SUBMITTAL OF HANFORD FACILITY RESOURCE CONSERVATION AND RECOVERY ACT (RCRA) PERMIT MODIFICATION NOTIFICATION FORM 24590-WTP-PCN-ENV-05-013

Modification Notification Form 24590-WTP-PCN-ENV-05-013 updates the Engineering Specification (24590-PTF-3PS-MWK0-TP001) for Activated Carbon Bed Adsorbers found in Appendix 7.7 of the Reference. The permit version of the specification is being replaced by the attached engineering source document. Permit version and source documents are not identical. Many aspects of the permit document (e.g., ghosting, certain notes, references, holds, etc.) have no counterpart or equivalent on the source document. Potential permit affecting changes between the current and previous versions of the source document are summarized on the permit change notice form.

The purpose of this Class 1 modification is to update 24590-WTP-3PS-MWK0-TP001, *Engineering Specification for Activated Carbon Bed Adsorbers*.

Appendix 7.7			
Replace:	24590-WTP-3PS-MWK0-TP001, Rev. 0	With:	24590-WTP-3PS-MWK0-T0001, Rev. 3

Figure 1 HLW Activated Carbon Bed Adsorber Schematic

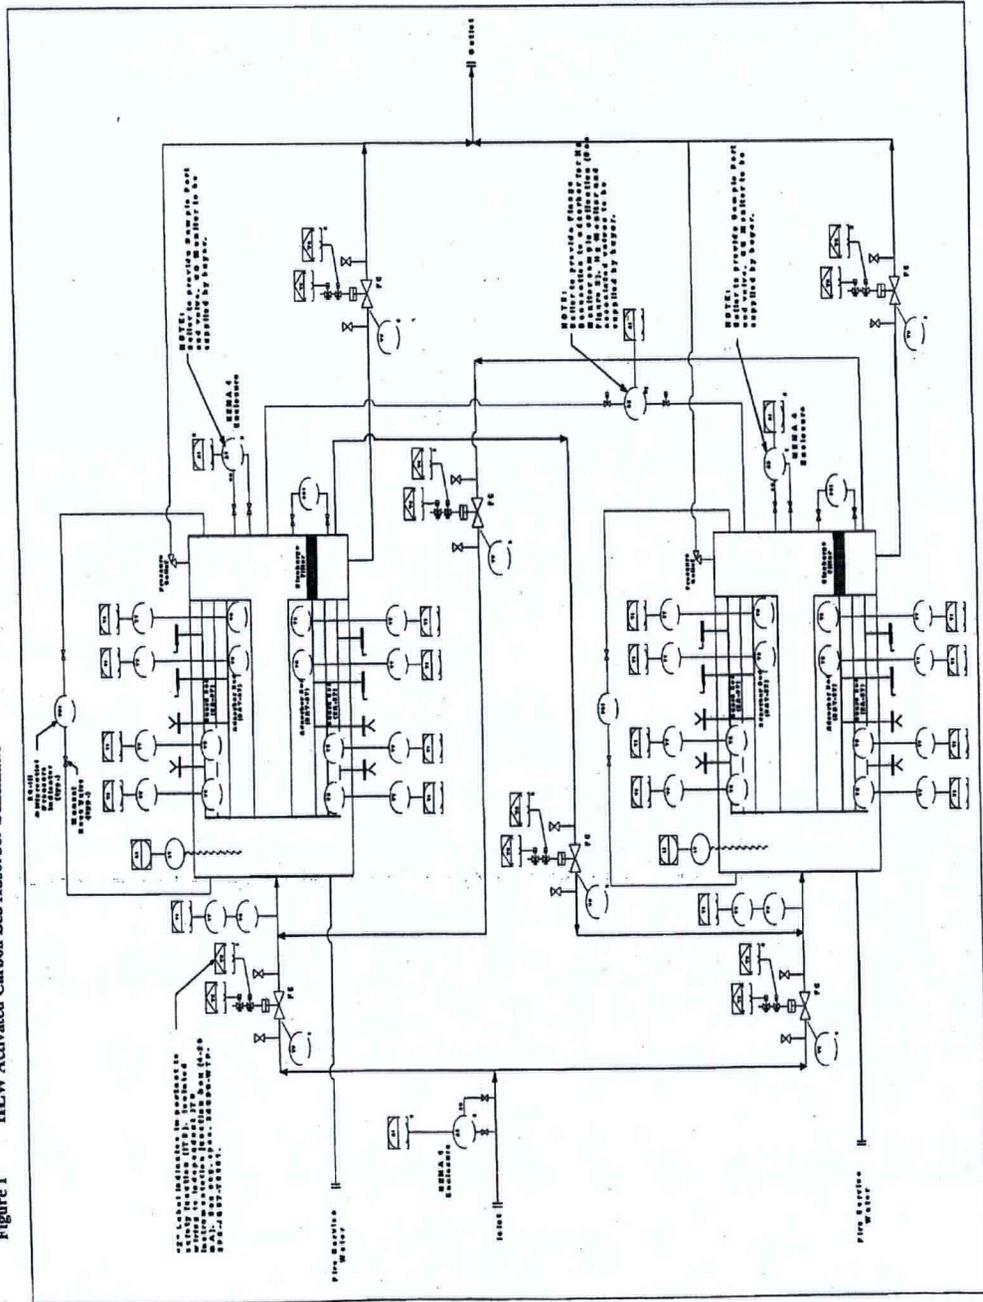
- Revised Figures 1 and 2 to clarify instrumentation requirements.
- Changed CO and COx analyzers from supplier's scope to buyer's scope (Section 3.16.2).

Figure 2 LAW Activated Carbon Bed Adsorber Schematic

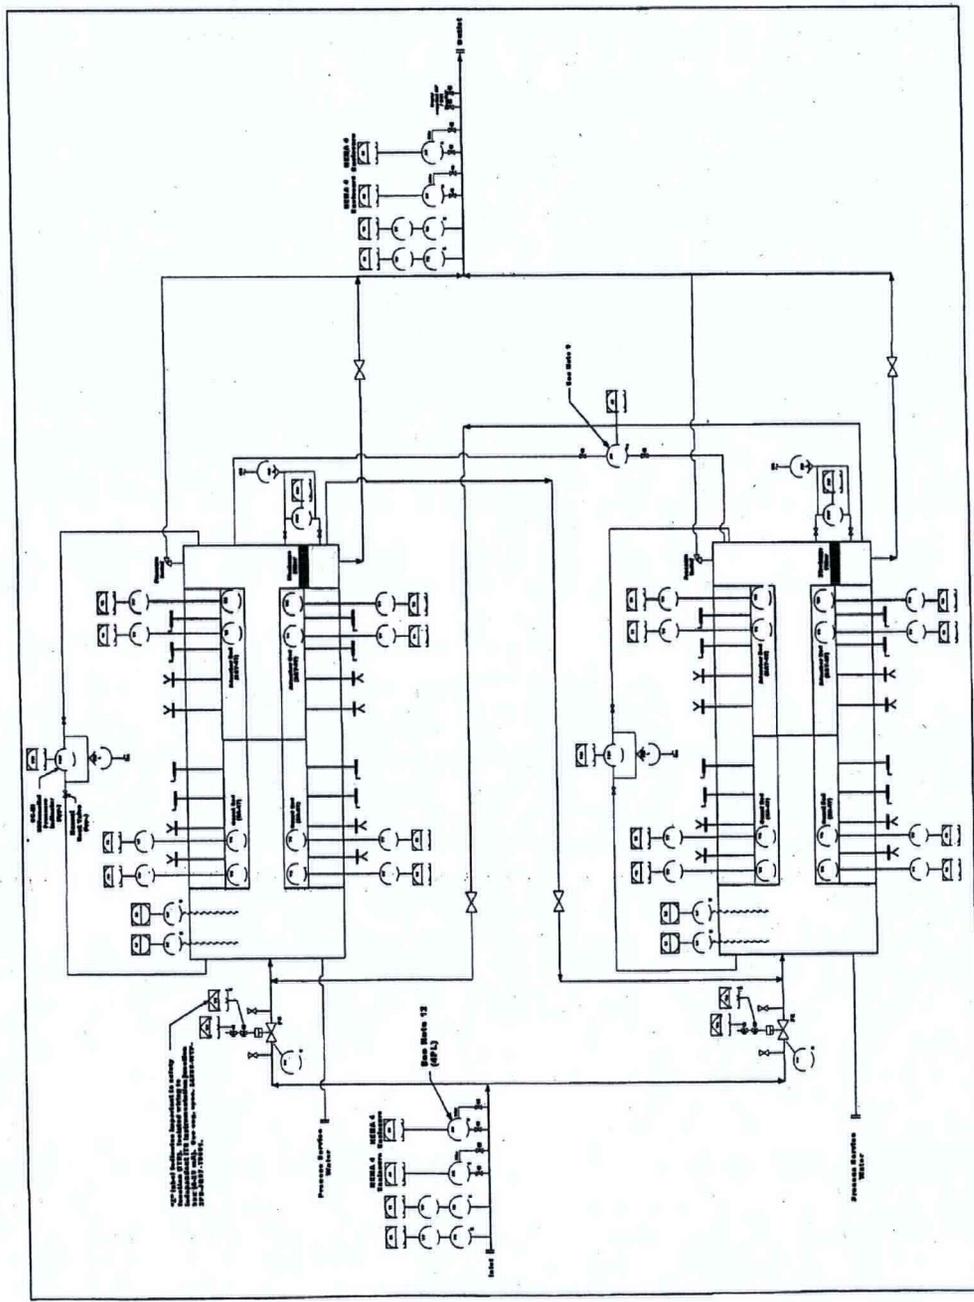
- Revised LAW instrumentation requirements for remote mounting of analyzers and transmitters (Section 3.16.2.10).
- Reformatted Section 3.4, Performance.

Figure 3 Mercury Gas Monitor Probe Flange Connection

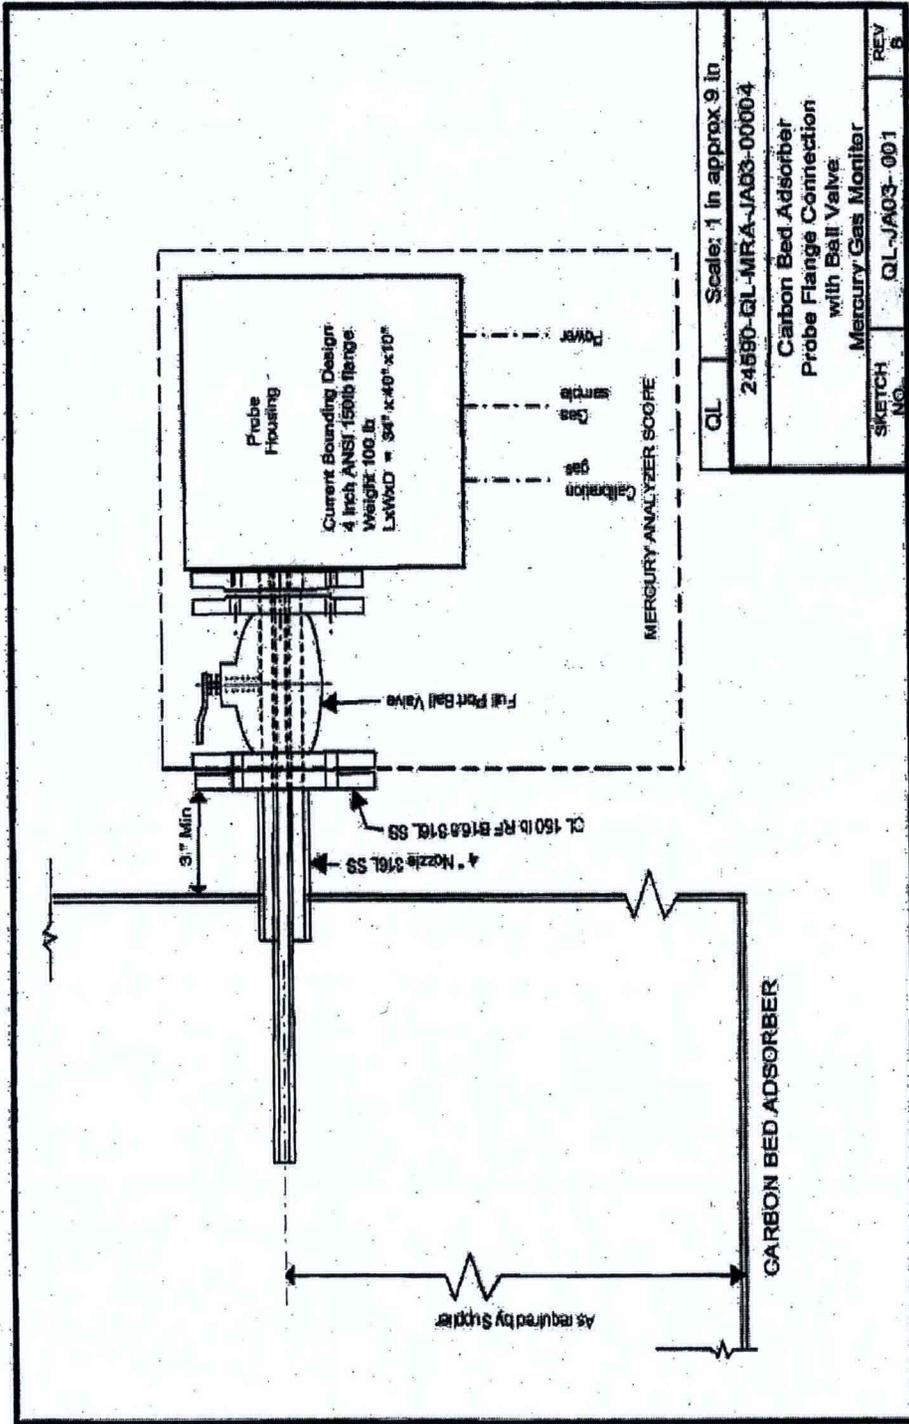
- Added Figure 3, Hg Monitor Probe connection detail.
- Added Section 5.5, Coating, to add project coating specification.
- Deleted Section 2.2.7, WAC 296-24, General Safety and Health Standards.
